I PROJECT:	Wynot Public School Addition & Renovation	PROJECT NO.	L14208
FROM:	BVH Architects	DATE:	17 March 2016
TO:	All Bidders	ADDENDUM NO.	1

Wynot Public School Addition and Renovation
R.O. Youker, Inc. Project #16005
Addendum 1 Items
3/17/2016

addendum no. 1

**VERTICAL CIRCULATION
PLANS & SECTIONS**

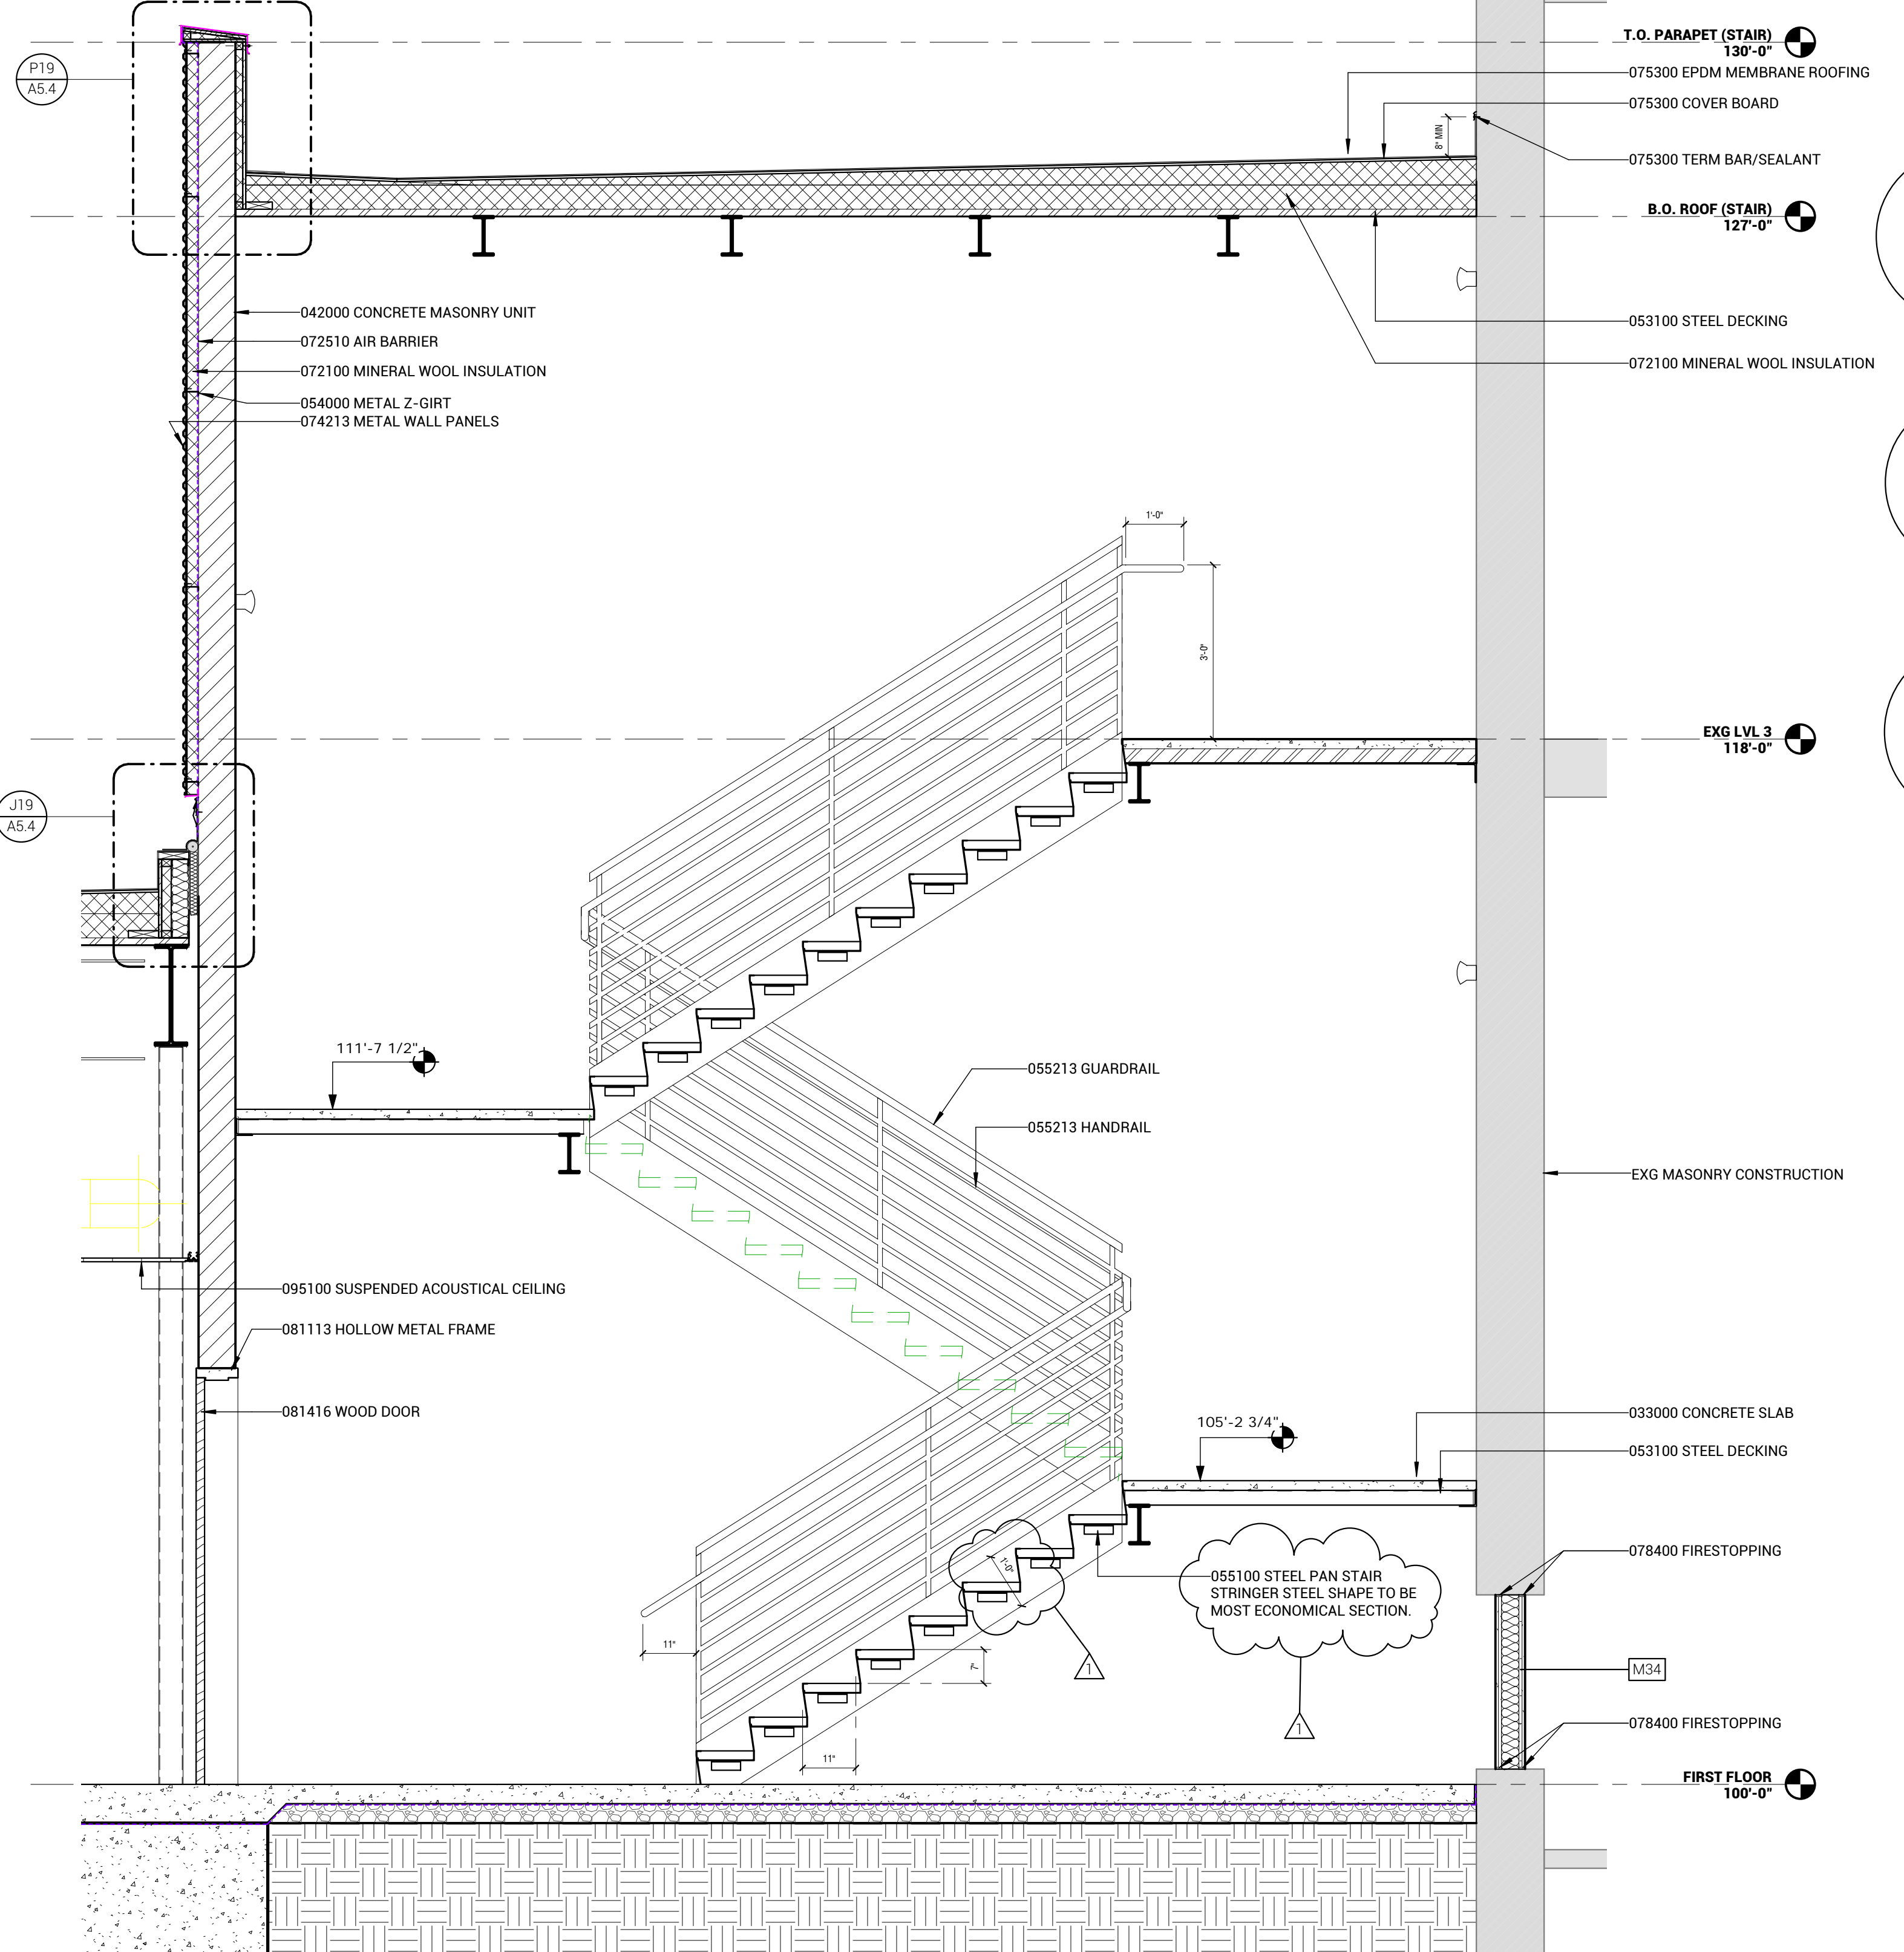
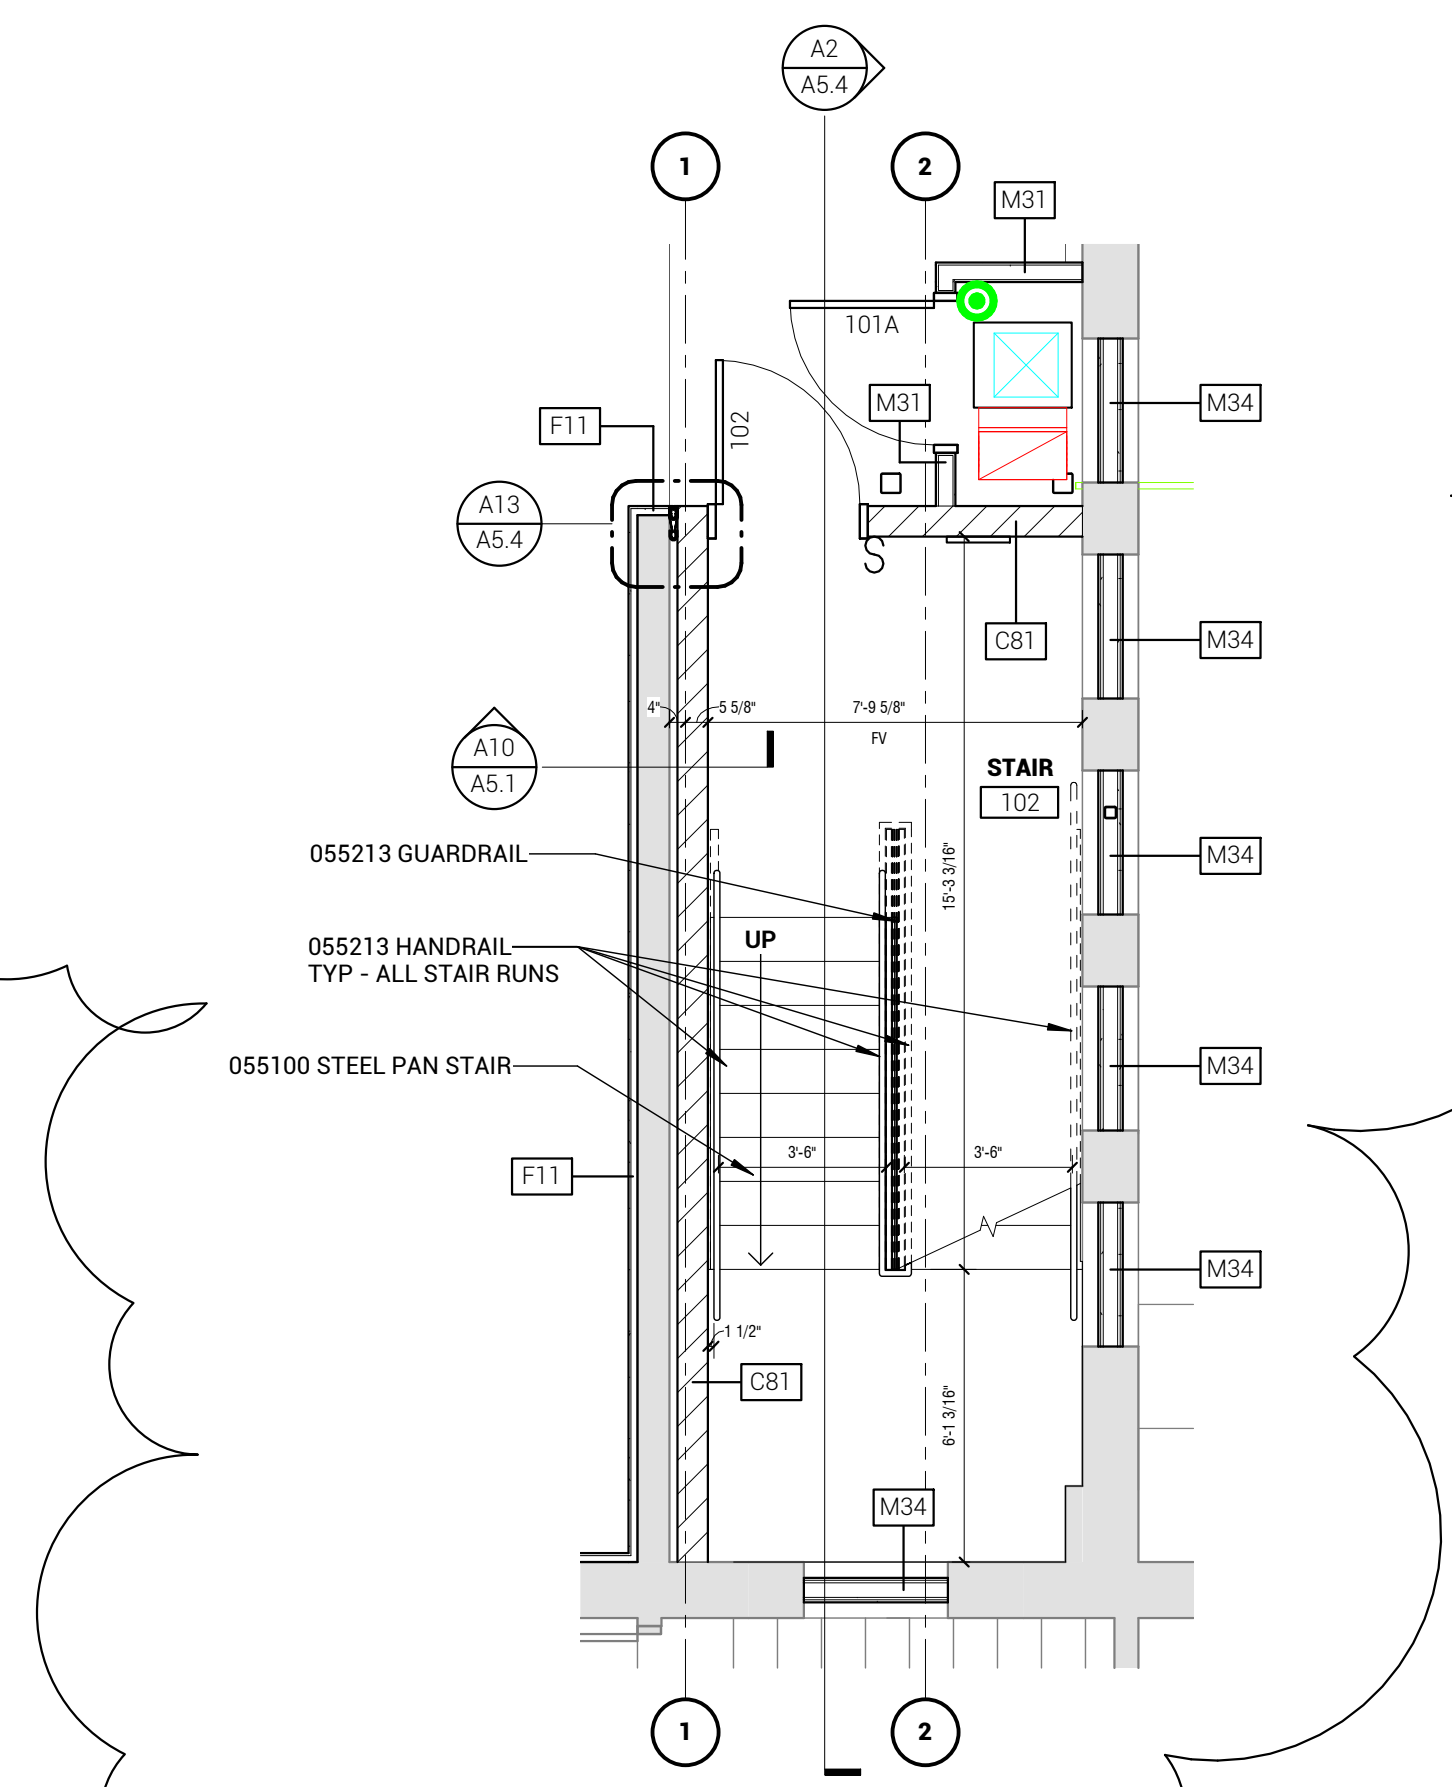
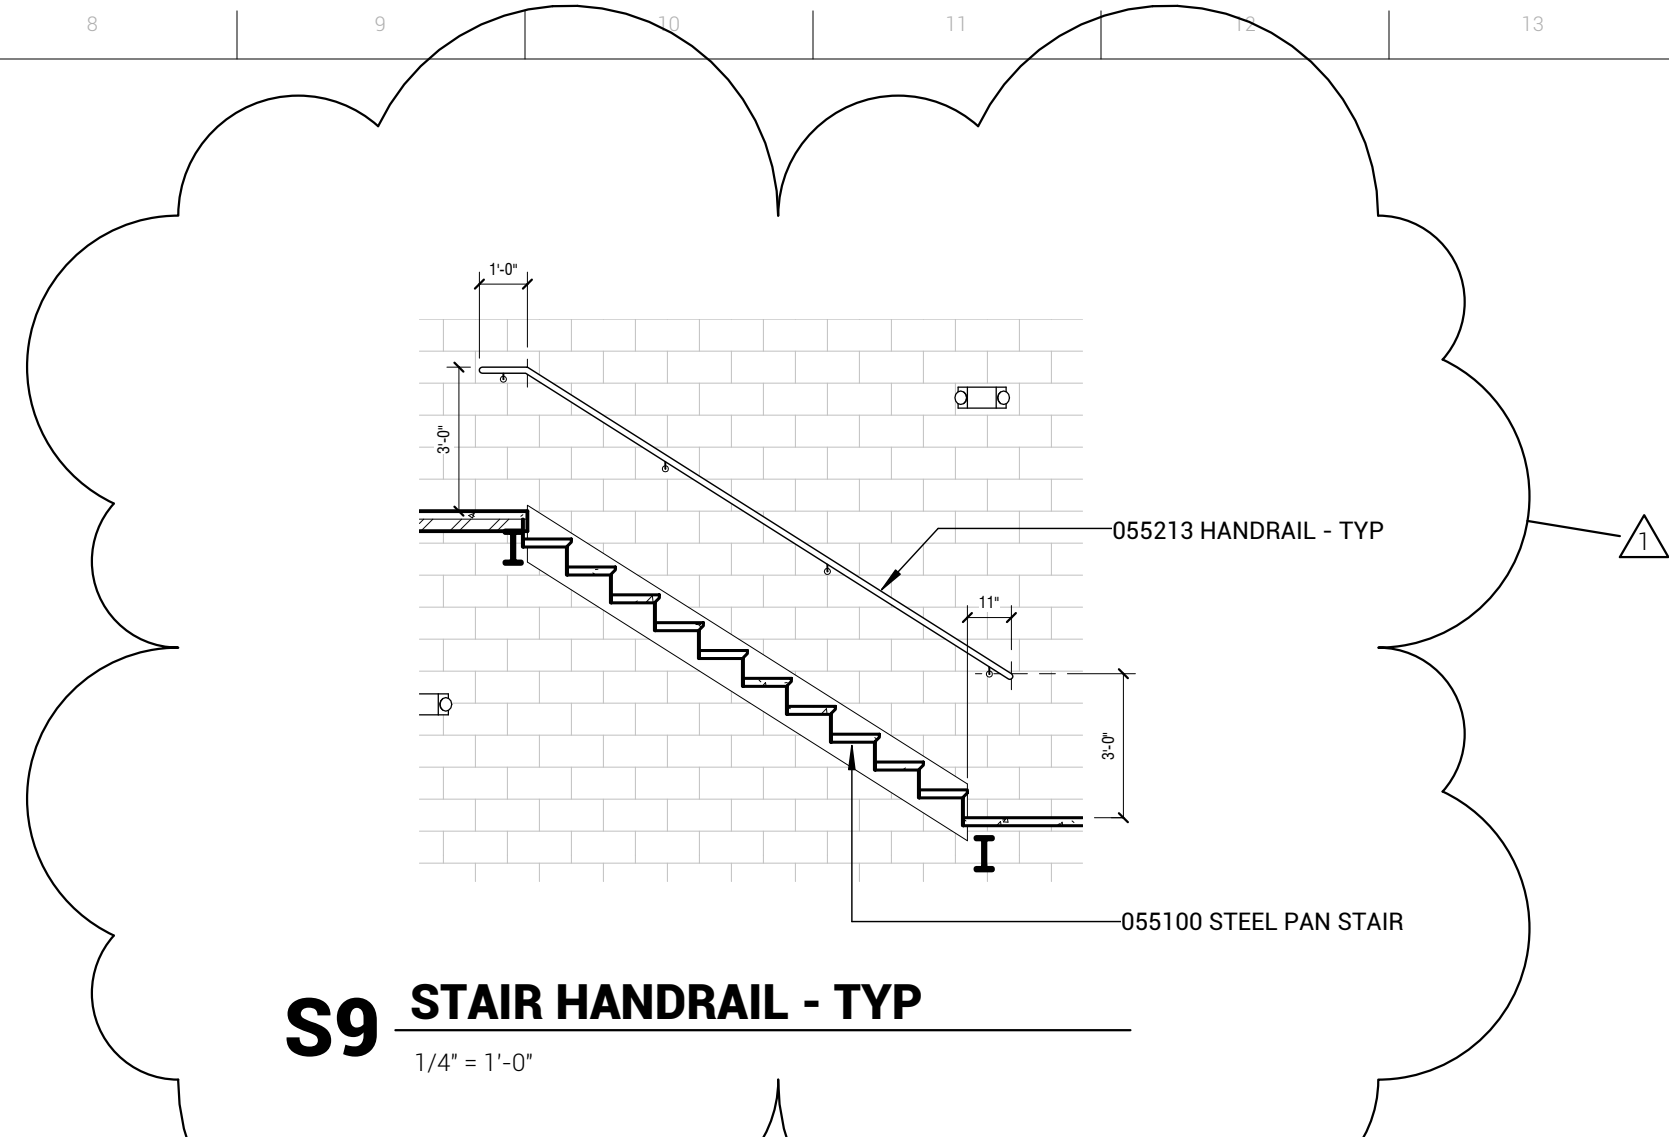
6. Sheet A5.4 Vertical Circulation Plans & Sections (refer to re-issued sheet A5.4)
 - a. Various drawing revisions.
 - b. Stair stringer to be 12" deep; steel shape to be most economical.
